# Notice of Application for a Planning Permit

The land affected by the application is located at: The application is for a permit to:			L228 PS649678 V11462 F018 25 Solid Drive, Pakenham VIC 3810

SECTION 54 RESPONSE PLANNING APPLICATION T240260 PA 25 SOLID DRIVE, PAKENHAM

## SECTION 50 AMENDMENT IN RESPONSE TO COUNCILS DESIGN CONCERNS PLANNING APPLICATION T240260 PA 25 SOLID DRIVE, PAKENHAM

Figure 1 – Previously Proposed South Elevation Viewed From Solid Drive

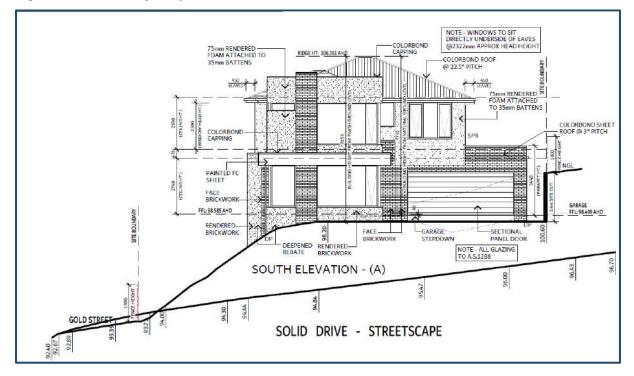
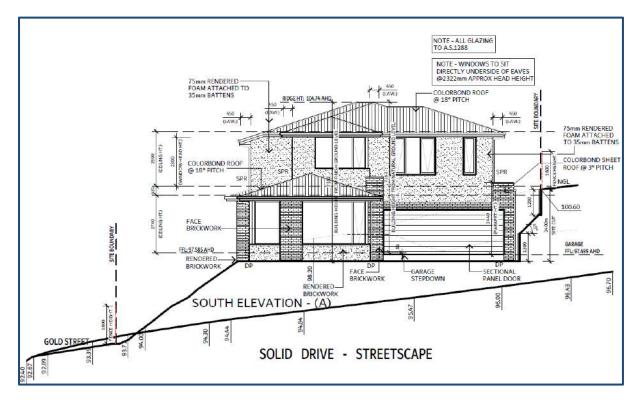
The southern elevation has been redesigned in harmony with the western elevation improvements, incorporating complementary modifications to reduce the dwelling's visual impact. The decrease in overall building height and reduction in roof pitch reduces the presence of the dwelling with the streetscape. The height of the dwelling is now 7.552 instead of 8.151 metres when presented from the southern elevation. This is responsive to Council's recommendation to reduce the building height.

The recission of the first floor introduces a Colourbond pitched roof between the ground and first floor. This design change assists in providing greater articulation between the ground and first floor. The windows of the upper floor have also been reconfigured. rendered foam wall and brickwork constructed into the roof of the previously proposed south elevation is now removed.

Figure 3 – Previously Proposed West Elevation Viewed From Solid Drive

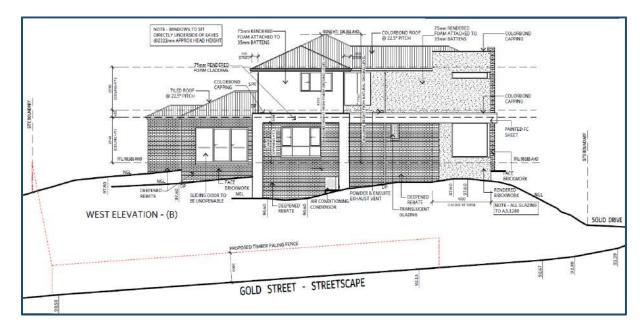
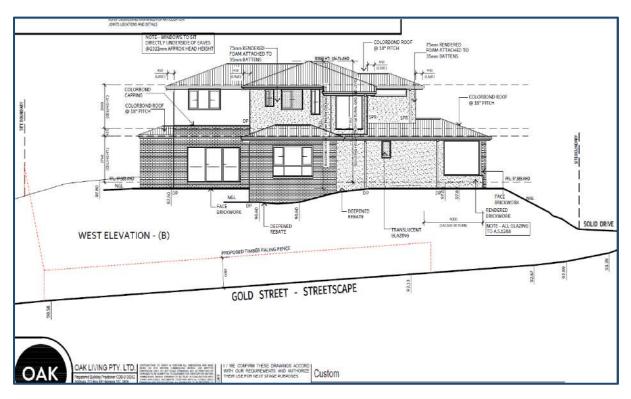
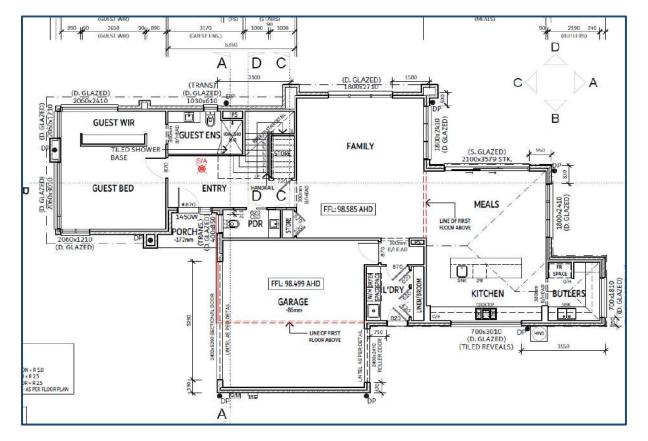
The western elevation design has been amended in response to Council's advice.

The previously sheer wall has been broken into stepped, recessed volumes, with the first floor now set back from the ground floor (as indicated by the dashed red line on the amended ground floor plan). This tiered approach softens the transition between levels and reduces the elevation's imposing presence.

There will now be a Colourbond pitched roof located above the family room, introducing a greater variety in material finishes between the ground and first floor. This design change assists in providing greater articulation between the ground and first floor.

Overall the amended western elevation is now more articulated from Gold Street, with a variety of building heights. Revised eaves (guest bedroom and butler's room roofs) further diminish visual bulk and add shadow lines for depth.
